**Basement Impact
Assessment Audit**

135-149 Shaftesbury Avenue,
London WC2H 8AH

For
London Borough of Camden

Project No.
14006-68

Historical Map Extract provided by
Covent Garden Community Association

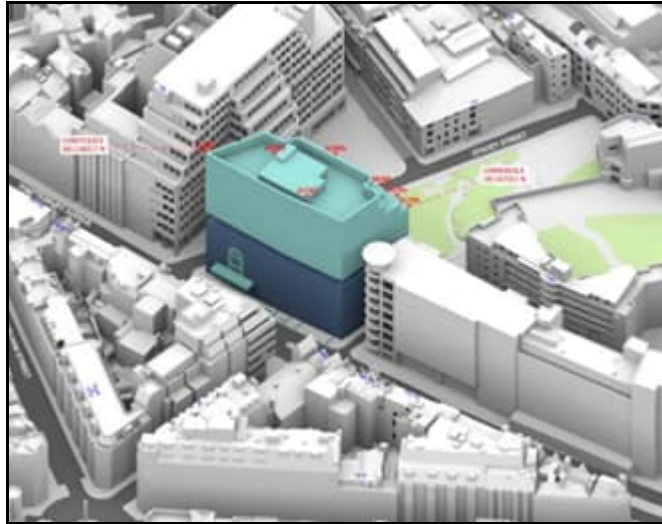
2. Is there any record in Camden's archives of the water courses or wells running under this site? A local historian sent us the Newton recreated map for 1534 which implies that a water course ran under the Odeon site with a pool there or nearby, as shown in the snip below.

Notwithstanding paragraph 4.1 of applicant's Basement Impact Assessment, which says that "the nearest surface water feature is 786 m to the southeast of the site", given the proposal to dig out a 3rd and 4th basement, it would be good to know if there is anything further down. A well was found close to this site underneath 4 Flitcroft Street during a recent redevelopment, and neighbours tell me that they are still having problems with water in the basement there. This is not surprising as the 12th century hospital is likely to have been built near at least one good water source.
